Access Compliance Report

Public Rights-of-Way

(Curb Ramps)

Intersection ID: 4523	Main Street: FELDBANK_DR	Cross Street: TRINITY_RD	Location: SW
ADA ID: 5AFF01AFD087	Ramp Type: PerpDiag	Initial Pass/Fail: Fail	Overall Compliance: No
			Severity Score: 33.75

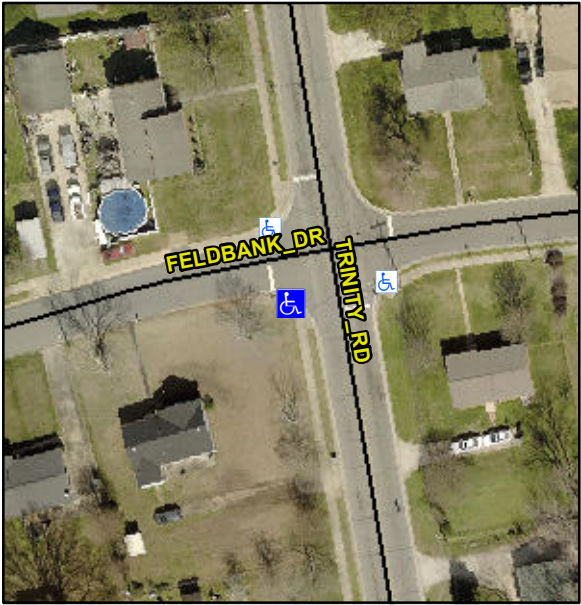
Codes/Mitigation Info/Possible Solution			Field Measurements/Component Compliance		
	Possible Solutions:		Compliance	Description	Data
	Remove & Replace Curb Ramp With Two New Directional Ramps or Equivalent.		N/A	Ramp Length (in)	60.0
			No	Ramp Width (in)	37.0
			N/A	Flare Type LT	N/A
			N/A	Flare Slope LT (%)	N/A
			N/A	Flare Traversable LT?	N/A
			N/A	Landing Length (in)	N/A
			N/A	Landing Width (in)	N/A
			N/A	Landing Slope (%)	N/A
			N/A	Landing X Slope (%)	N/A
<p>Surveyor Notes:</p> <p>N/A</p> <p>PROW/ADA:</p> <p>Not Found, R304.5.1, R304.2.2</p>			N/A	Flare Type RT	N/A
			N/A	Flare Slope RT (%)	N/A
			N/A	Flare Traversable RT?	N/A
			N/A	DWS Provided?	N/A
			N/A	DWS Contrast?	N/A
			N/A	DWS Length (in)	N/A
			N/A	DWS Full Width?	N/A
			N/A	DWS Offset (in)	N/A
			N/A	Shared Landing?	N/A
			N/A	Gutter Ponding?	N/A
			N/A	Gutter Lip Ht (in)	1.0
			N/A	Painted X Walk1?	No
				X Walk 1 Direction	To E
			N/A	X Walk 1 Width (in)	N/A

X Walk 1 Slope (%)	2.8
				X Walk 1 X Slope (%)	1.2
			N/A	Ramp inside XWalk1?	N/A
				Road Slope (%)	0.0
				Road X Slope (%)	5.2
			N/A	Any Obstructions?	N/A
				Obstruction Type	
Total Cost:			\$	3200.00
